Docket No. 50-423

Reference: B. J. Youngblood letter to W. G. Council, Request for Additional
Information, dated June 19, 1984.

Millstone Nuclear Power Station, Unit No. 3
Probabilistic Safety Study (PSS)

Figure 720.74-1
Peak Acceleration Versus m_b
at R=5 km

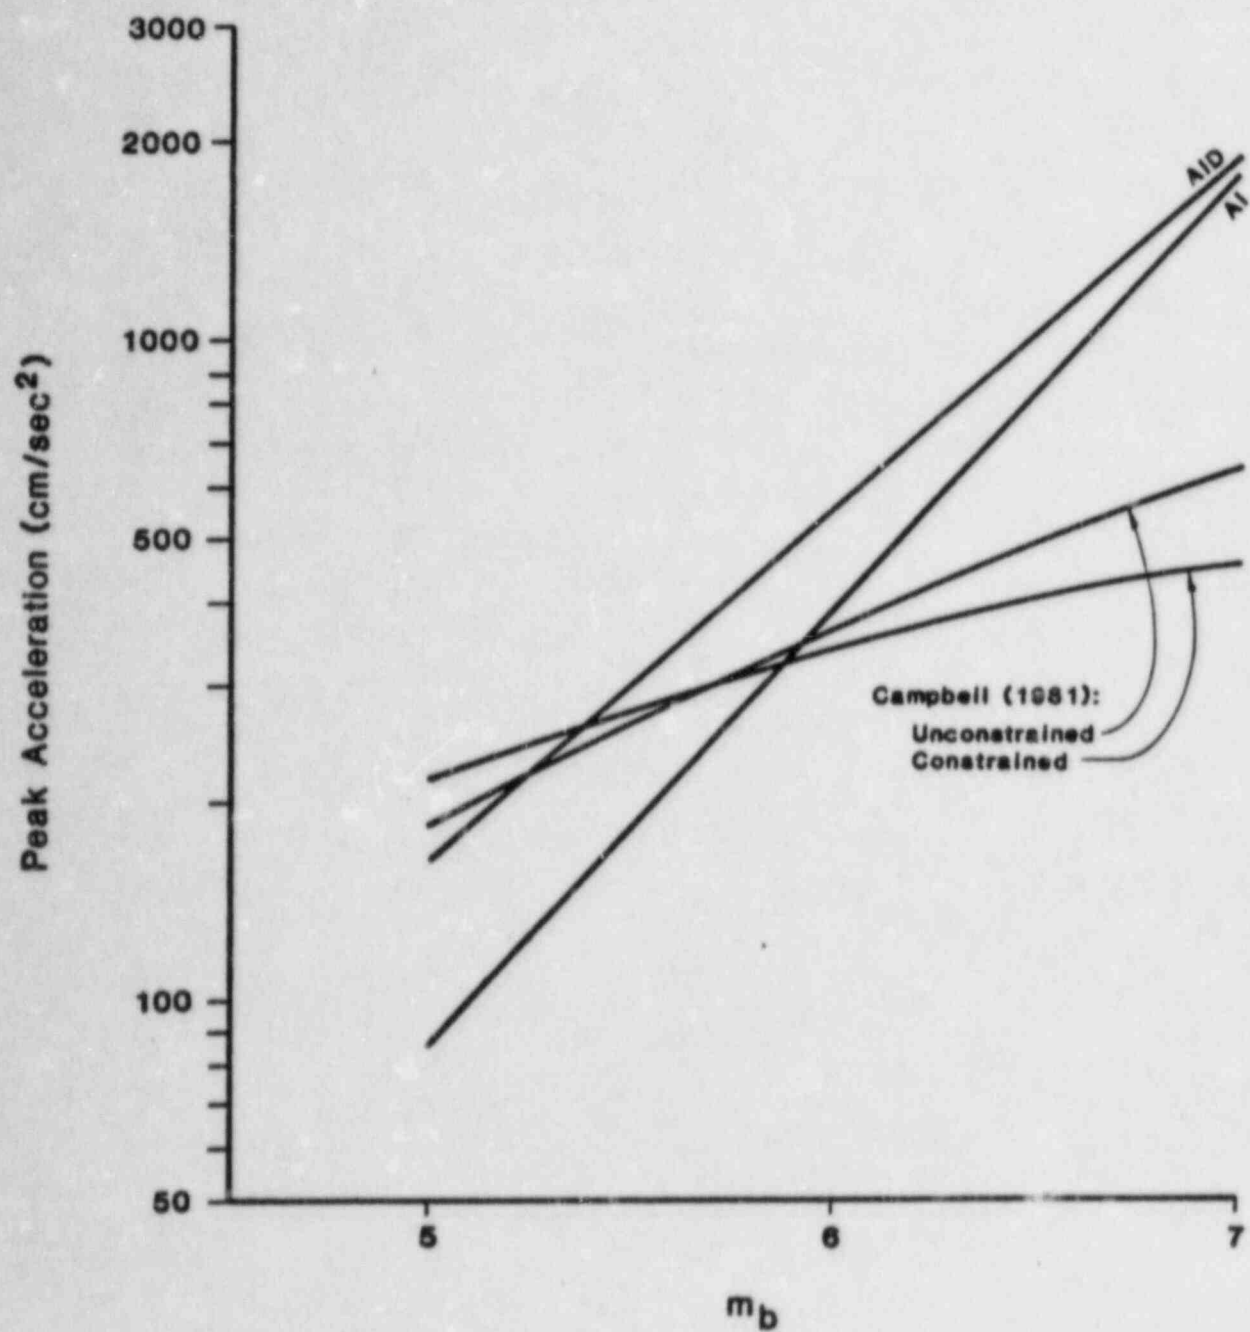
As reported in the Dames and Moore hazard report, two ground acceleration attenuation equations were derived from MM intensity attenuation using the relationship of Klimkiewicz (1982). The staff questions the validity of these relationships. These ground acceleration relationships predict lower near source accelerations for the same magnitude when compared to those of Campbell (1981a) whose near source eastern United States values are determined using near source western United States strong motion data.

- a) Why would near source ground motion (for the same m_b) be systematically lower in the east compared to the west, as you have assumed for these two equations?

Figure 720.74-1 shows a comparison between estimates made using the AI and AID attenuations, and those from Campbell (1981b), using both his 'constrained' and 'unconstrained' models for California. These estimates are made at a distance of 5 km (epicentral distance in the case of AI and AID, surface fault distance in the case of Campbell). Figure 720.74-2 shows a similar comparison at a distance of 10 km. This indicates the same general results. To make a comparison on the basis of m_b , the conversion from moment magnitude to m_b recommended by Campbell (1981a) was used.

Peak accelerations from the AID equation equals or exceeds Campbell's near estimates at all magnitudes above 5.3, and the peak accelerations AI equation exceeds Campbell's estimates at magnitudes above 5.8. For Millstone 3 the majority of seismic hazard comes from magnitudes above 5.5, and therefore the higher accelerations predicted by the AI and AID equations is conservative. In that little seismic hazard comes from earthquakes of magnitude less than 5.5 there is no significant effect on seismic hazard risk from Campbell's accelerations being higher than the AI and AID accelerations.

Figure 720.74-4

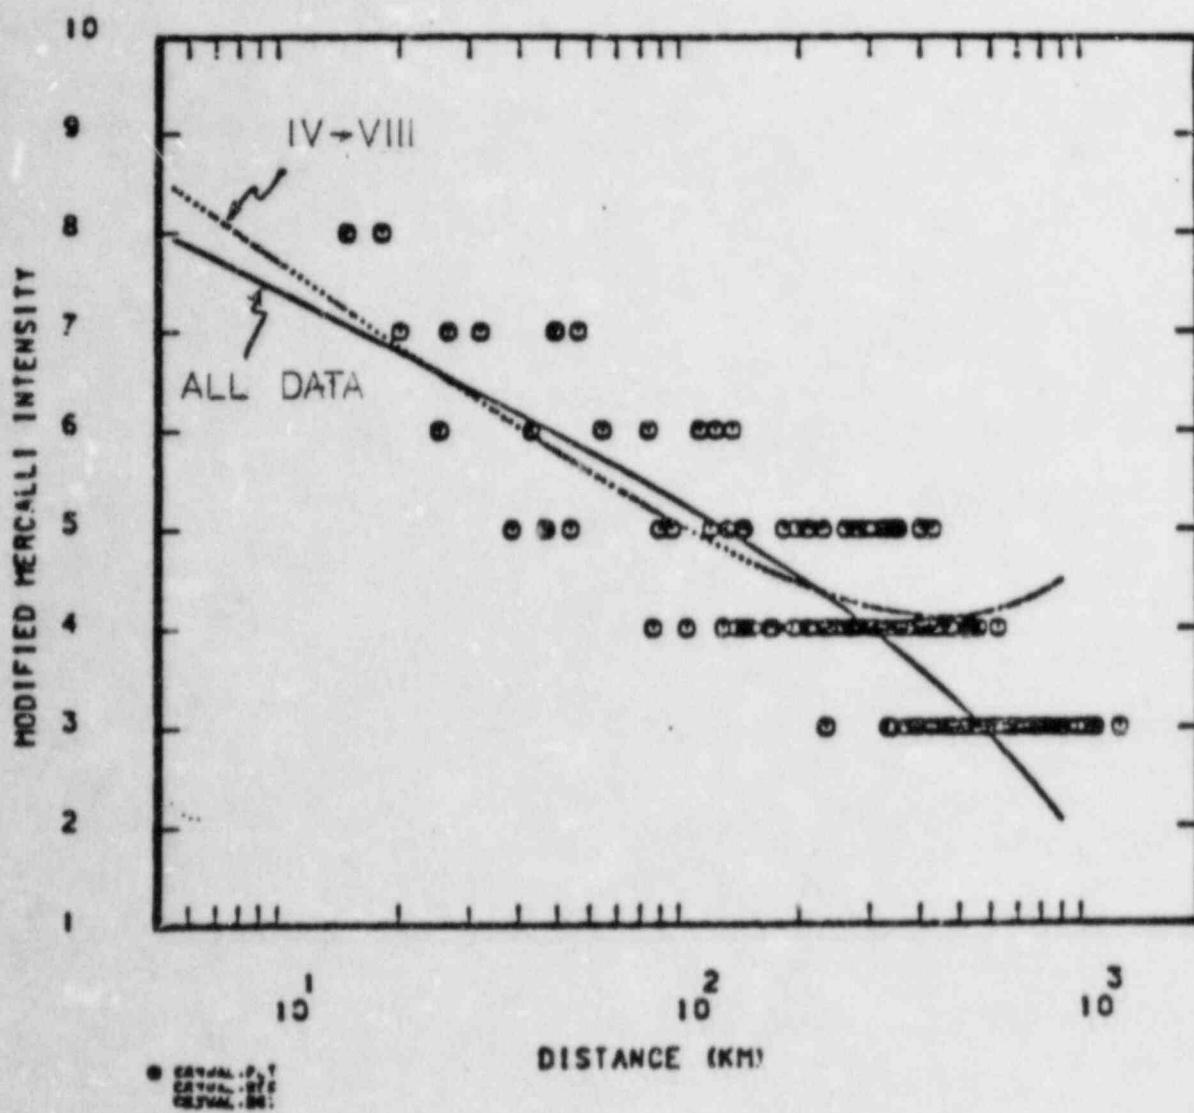
The staff is concerned that the intensity attenuation of Klimiewicz, (1982) is strongly influenced by intensities less than MMI=IV. It is likely that ground motion is not linear with MM intensity (see for example actual results of Trifunac and Brady, 1975, Murphy and O'Brien, 1978). Weston Geophysical has noted in the New Brunswick earthquake report (pg. 138) that the intensity attenuation model may be low for near epicentral distances. If intensities less than MMI=IV were removed from the intensity-distance set, would the intensity attenuation equation and thus the two ground acceleration attenuation equations result in higher seismic hazard curves compared to those assumed? If so, revise your seismic hazard curves accordingly.

In lieu of performing an analysis on all intensity data available for the northeastern US, it is more informative to show the effects of removing some intensities from the data set using just one earthquake. Figure 720.74-4 shows intensity data from the 1944 Cornwall-Massena earthquake, which has one of the least disperse sets of observations in northeastern North America. The solid line is a fit using all the plotted data; the dotted line is fit through intensities IV and above. It should be noted that intensities plotted as III are an undifferentiated combination of intensities I through III.

At distances less than 15 km and greater than 300 km the predictions of the two models differ. The dotted curve which excludes ground motion less than intensity IV is obviously incorrect when it shows increasing intensity at greater distances. At close distances (less than 15 km) there are no data to support either model, but theoretical considerations clearly give more weight to the solid curve by the following reasoning.

Figure 720.75-1

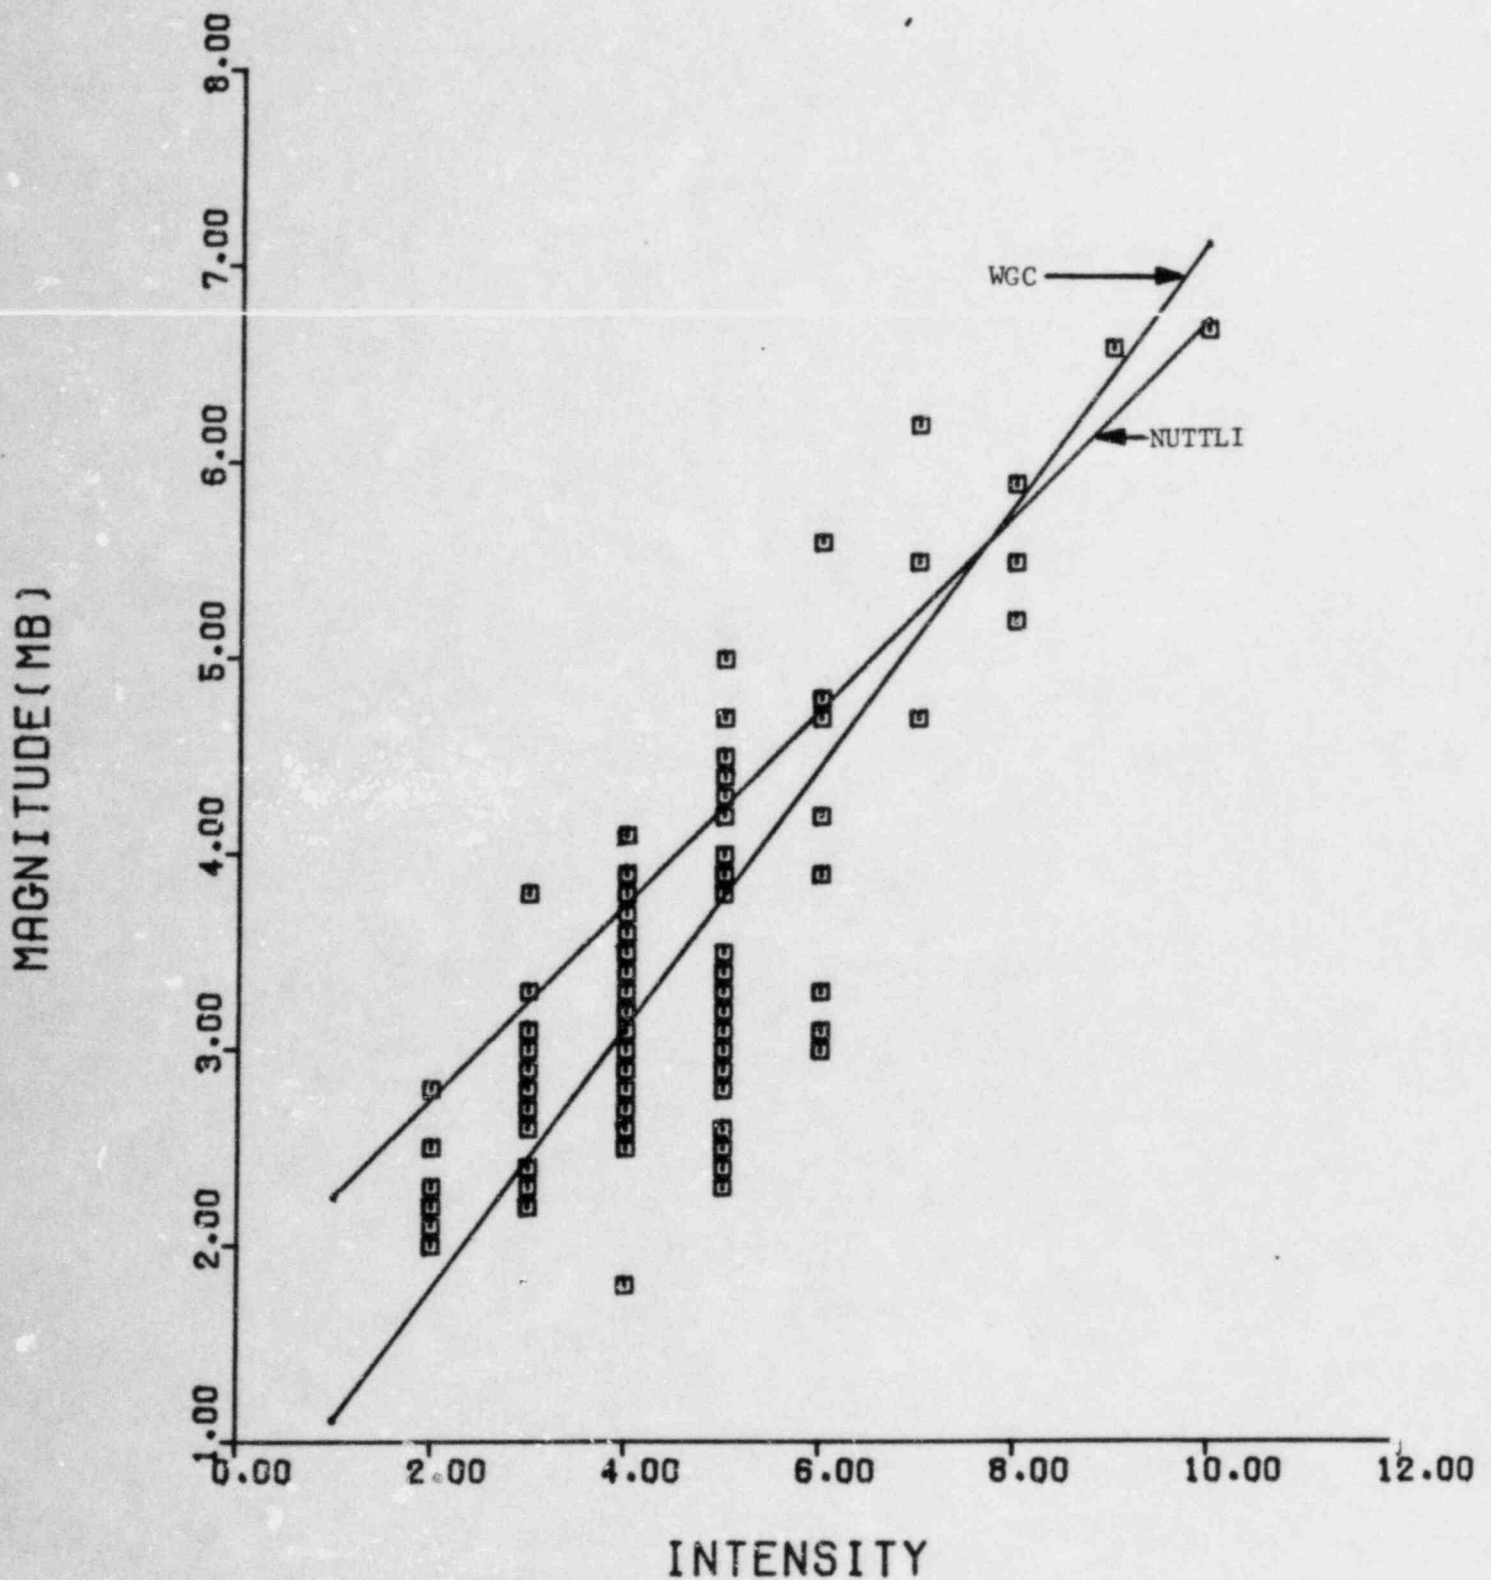
As noted in the attached internal staff memorandum (Enclosure 2), the staff questions the validity of the Weston (1982) epicentral intensity to magnitude equation. This equation is given a weight of 50% in your hazard analysis. Provide a response to the concerns in the attached memorandum, and if necessary, revise the seismic hazard curves assumed in your analysis.

The most appropriate equation to use to convert Modified Mercalli Intensity (MMI) to body wave magnitude (m_b) in the northeast is not resolvable theoretically, because intensity is an observed, empirical quantity. Some insight into the appropriate conversion can be obtained by examining all available earthquake data for the northeast that have both an instrumentally measured magnitude (m_b) and an assigned epicentral intensity. Table 720.75-1 is a listing of events meeting this criteria. These events are compiled primarily from the Chiburis catalog with additional events from Street and Turcotte and Yankee Atomic Electric Company Report #1331 (YAEC #1331). The events from YAEC-1331 come from the Weston Geophysical Corporation (WGC) catalog, and in particular are a subset of the events used in determination of the WGC conversion that are not found in either the Street or Chiburis data set. Figure 720.75-1 shows a plot of epicentral intensity versus body wave magnitude (m_b) for these events, along with the Nuttli and WGC intensity to magnitude conversions.

While the results vary among the individual subsets of data, the overall conclusion is that the WGC conversion provides a better fit, or at least as good a fit, to the data, as does the Nuttli conversion. This is consistent with the idea that characteristics of northeast US earthquakes, at least insofar as intensities are concerned, are slightly different from those of other earthquakes in the US.

Figure 720.76 -1
Acceleration Hazard Curves

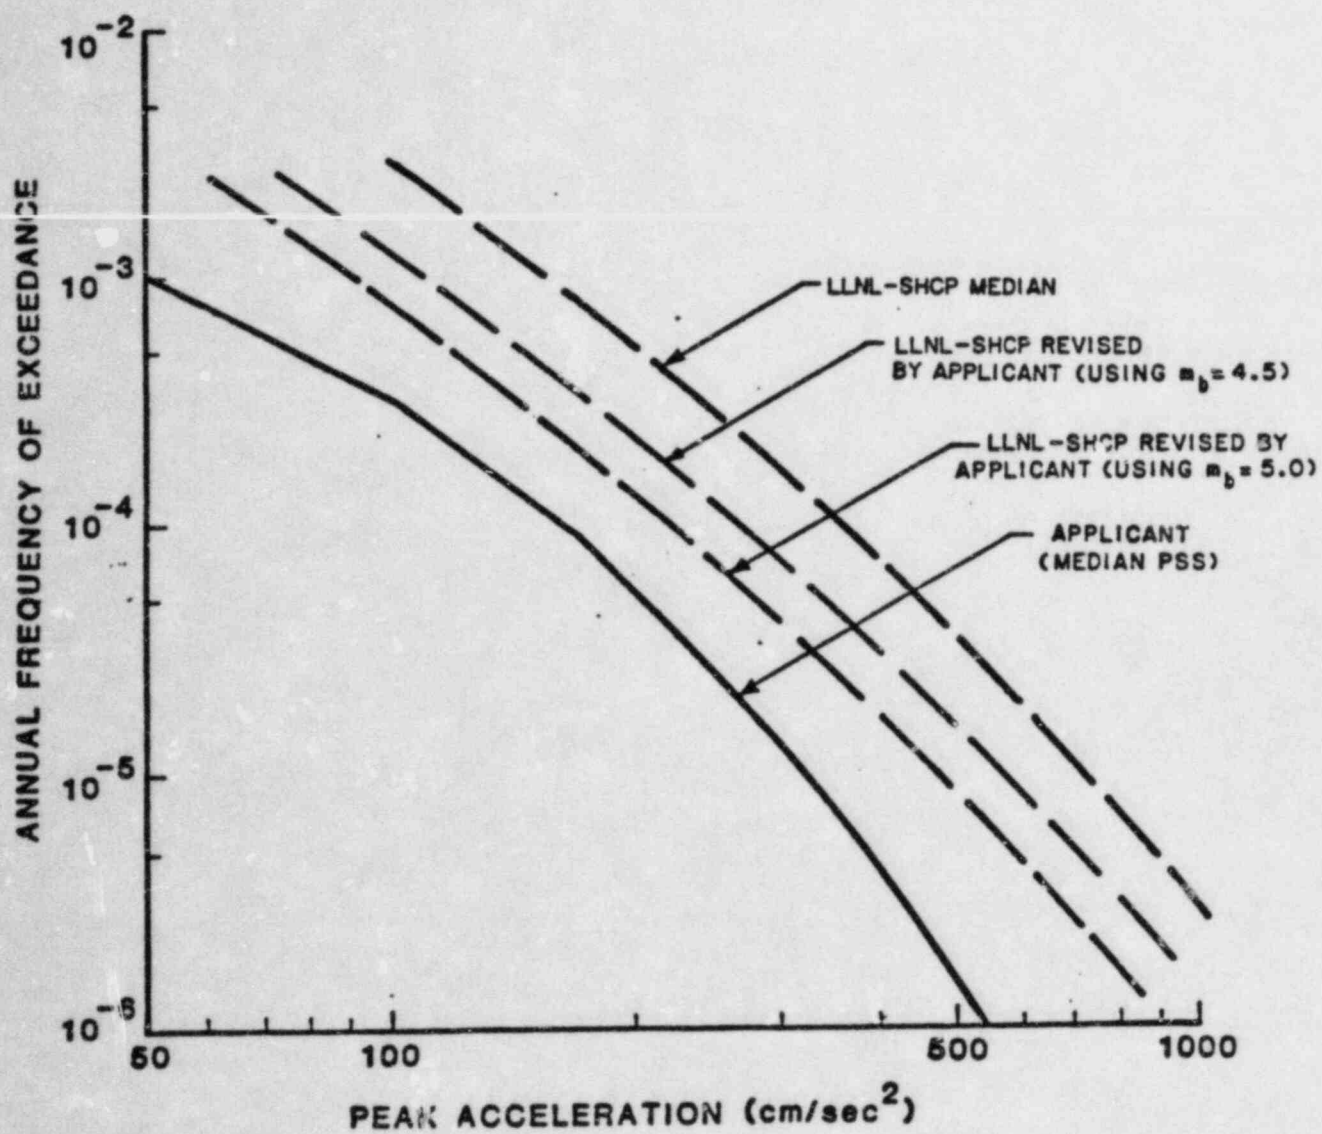
As part of an ongoing joint NRC Office of Research and Office of Reactor Regulation effort, the staff is assessing the seismic hazard for all nuclear power plants east of the Rocky Mountains. The Millstone site is included in the first ten sites. Results are discussed and displayed in NUREG/CR-3756, a copy of which was forwarded to you. The hazard results in NUREG/CR-3756 are significantly more conservative than you have assumed in the PSS.

- (a) The staff requests your comments on the above report, particularly with respect to differences between LLNL seismic hazard assumptions and those which you have used.
- (b) If there is any information in this report which would alter your hazard assumptions provide revised seismic hazard curves.

Thus, removing the major conservatisms identified in a preliminary review of the LLNL work means that the spectral amplitudes for a given probability level would decrease by 33% to 43%. A visual representation of the effect is shown on Figure 720.76-1. The peak ground acceleration hazard curve developed by the Applicant is shown as the solid line, and compared to it are several original and revised hazard curves from the LLNL study. The long dashed curves are LLNL median curves, as originally published and as revised by reducing the accelerations at a given probability level to remove the conservatisms discussed above. These reduction factors are shown in Table 720.76-1. The revised median curves lie much closer to the Applicant's result. An original and a revised LLNL 15% fractile curve is shown in Figure 720.76-2. The revised curve clearly encompasses the Applicant's curve, meaning that the Applicant's results and the LLNL revised median results match within one-half standard deviation of the uncertainty in the hazard curves.

FIGURE 720.78-1. COMPARISON OF PEAK GROUND VELOCITY TO PEAK GROUND ACCELERATION RATIOS WITH MEDIAN SITE-SPECIFIC RESPONSE SPECTRUM

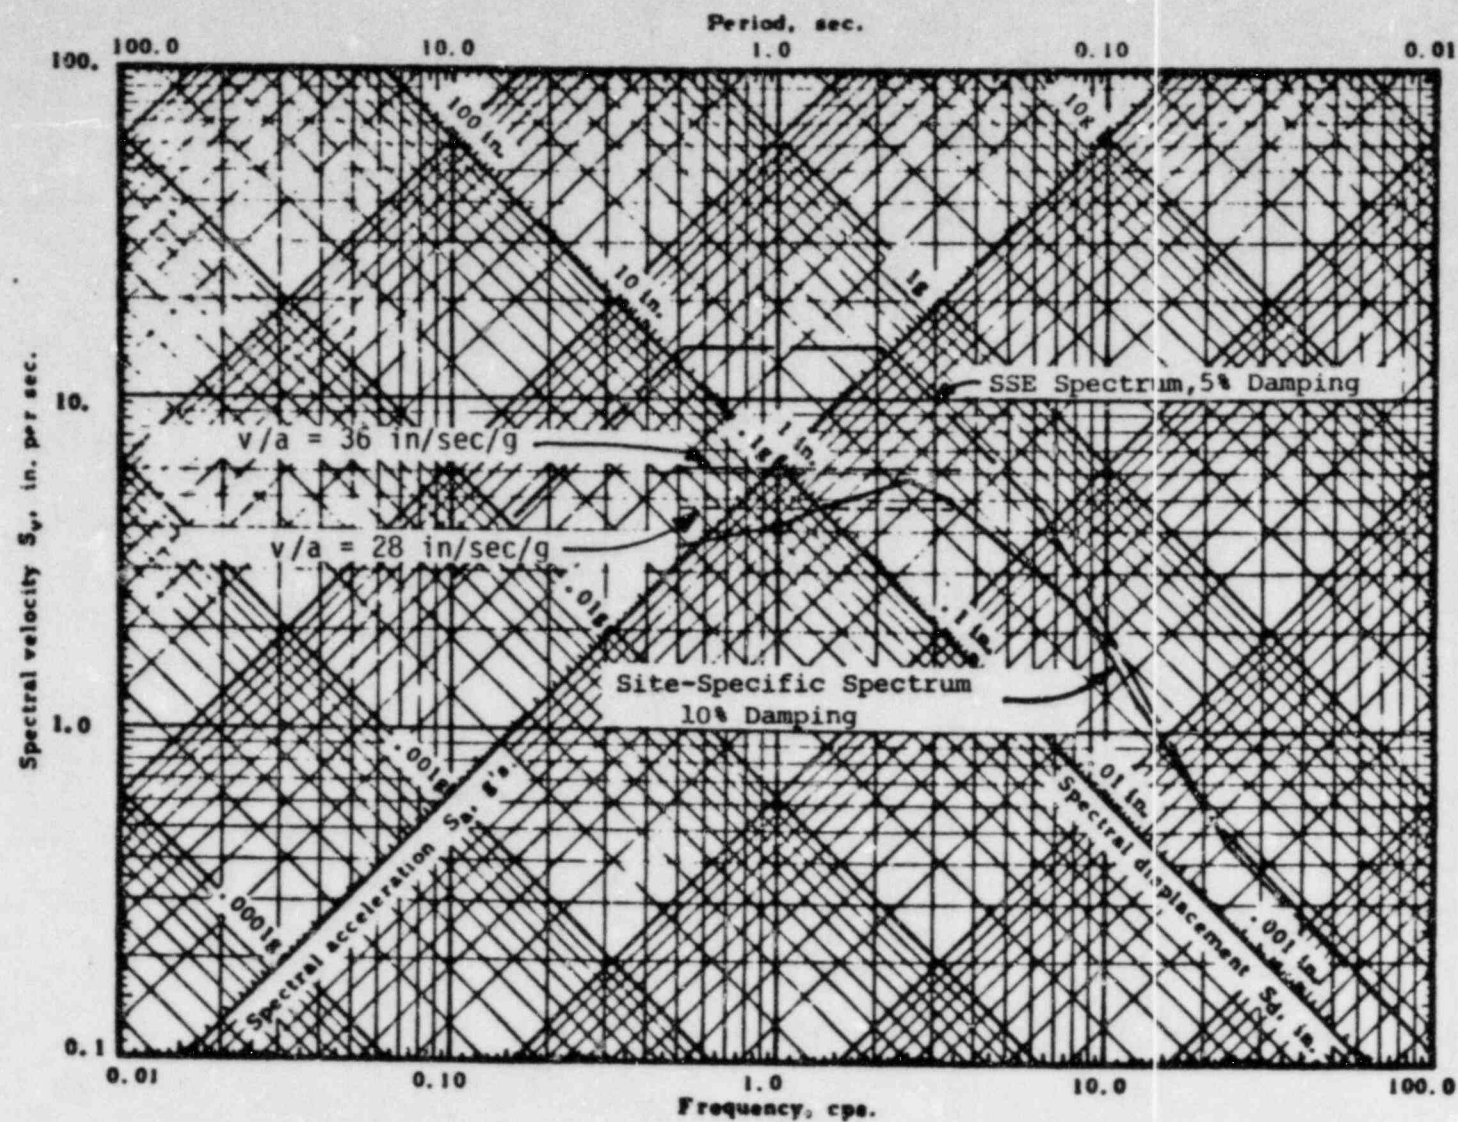
The staff questions the validity of using a peak bedrock velocity of 28 in/sec/g for the calculation of sliding-induced failure. This value is inconsistent with both that recommended by Newmark and Hall (NUREG/CR-0098, 1978), and that calculated directly for the Millstone site reported in NUREG/CR-3756 (see Question 3). Additionally, the value of 28 in/sec/g based upon only a few Western United States strong motion records may not be appropriate for the Eastern United States where attenuation characteristics are different. Provide a response to these concerns, and if necessary, revise your estimates of fragilities due to sliding-induced failure.

As shown in Figure 720.78-1, the median ten percent damped amplified ground response spectrum is exceeded by this velocity for frequencies less than about 1.4 Hz and greater than about 3.4 Hz. The peak ground velocity for the conservative v/a ratio of 36 in/sec/g, scaled to SSE peak ground acceleration, is:

As shown in Figure 720.78-1, the median ten percent damped ground response spectrum is exceeded by this peak ground velocity through the entire frequency range. This occurrence is not substantiated by real earthquakes.

Inspection of Figure 720.78-1 would imply a median v/a ratio somewhat less than 28 in/sec/g. It can be concluded that the selected median v/a ratio of 28 in/sec/g, while somewhat conservative, is more appropriate for use in the Millstone 3 fragilities evaluation than the conservative design value of 36 in/sec/g.
